**Flood Control Project Maintenance
Levee Inspections**

Maintenance Issue Types Only, Levee Inspection Report By Mile - Fall 2020

Butte County Department of Public Works

Waterway	Bank	Unit Miles	Inspection Start/End	Inspector
Unit No. 01 Mud Creek	Right	6.80	10/27/2020 10/27/2020	Makar Sokol

Photo 1 of 2 : UCIP_FA_2020_30388_55891.jpg

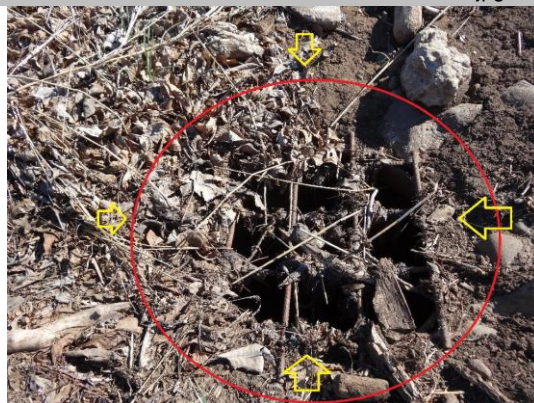
Comment Code					
Inspector Comment					
DS_ID:19221 FS_ID:30388 EP_NO: N/A Repair Type: Non-Urgent EVAL Issue: Crossing Status: Found UCIP Comments: CM Standpipe intake. Intake pipe with air vent. Steel rib-bar grit cover on the standpipe on landside levee toe.Needs cleaning and clearing on both ends of the pipe. FIELD_STRUCT_DESC: 24-inch corrugated metal gravity drainage pipe through the levee, 15 feet below the crown. Flap gate on the waterside (WS) end. Concrete U-shaped headwall on the WS end. Grouted riprap spillway on the WS end. Corrugated metal standpipe intake. Intake pipe with an air vent. Steel rib-bar grit cover on the standpipe on the landside (LS) toe. [Additional Reference(s): DWR Levee Log, 1992. USACE Sacramento O&M Manual 504, May 1965, (HLM 4.94)]. FS Date: 2/20/2014

WS view: U type concrete headwall, pipe, and flapgate on levee slope. Vegetation/soil debris blocking outlet.

Photo 2 of 3 : UCIP_FA_2020_31965_58394.jpg

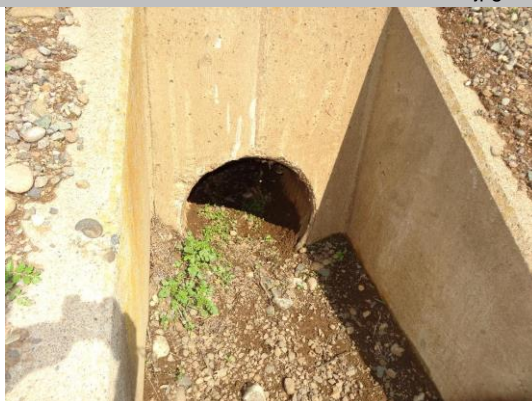
LS view: U type concrete headwall and CMP on levee slope. Vegetation debris and mud in inlet box.
